Mi00-29

DATE : October 2000	SECTION : 18 - Body
SUBJECT : MODIFICATIONS TO THE WIPER DRIVING MECHANISM FOR XLII SERIES VEHICLES

DRIVE MECHANISM – DRIVER'S SIDE

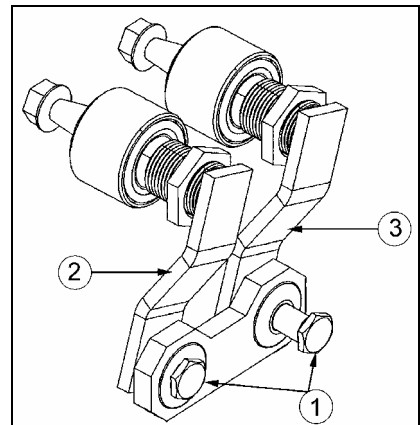
- : #507613 bolt (replace snap ring #504680)
- : #300435 pivot lever replace #300378
- : #300436 pivot lever replace #300345

DRIVING MECHANISM – MOTOR SIDE

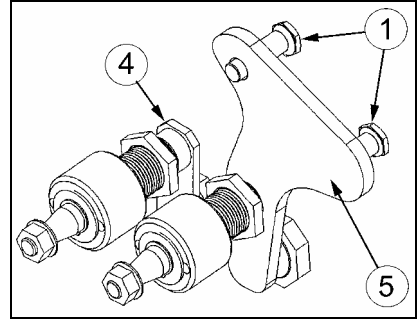
: #507613 (bolt replace snap ring #504680)

: #300443 pivot lever replace #300412

: #300442 replace #300416

WIPER MOTOR

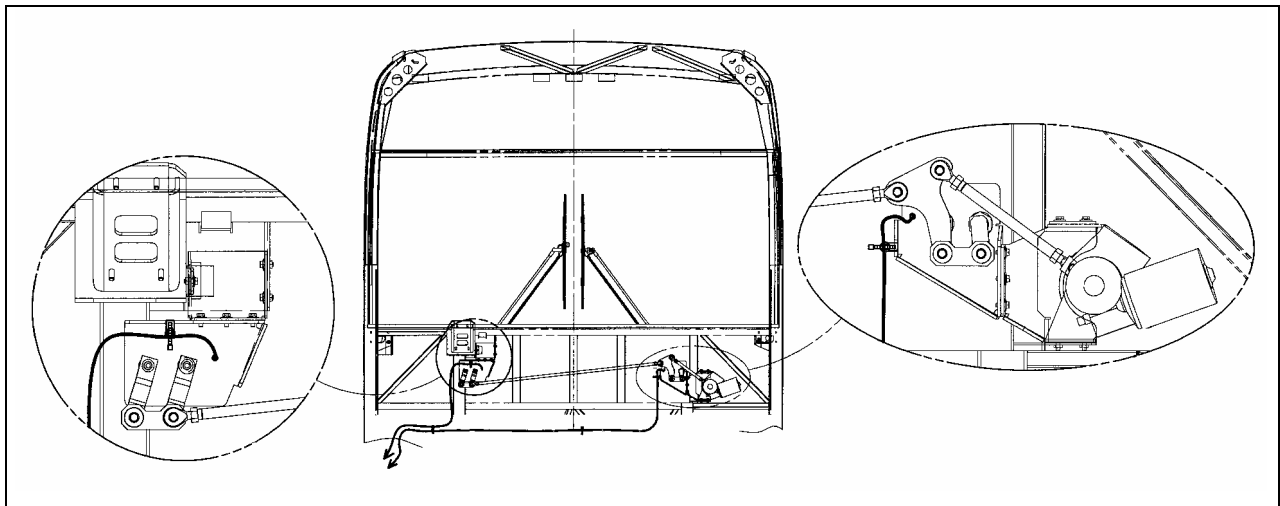
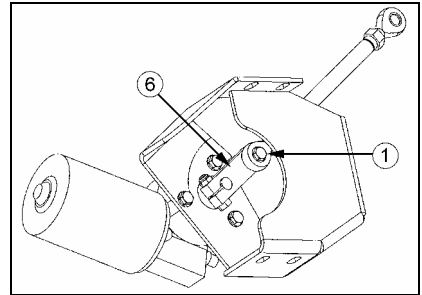
: #507613 bolt (replace snap ring #504680)

: #300445 crank arm replace #300406
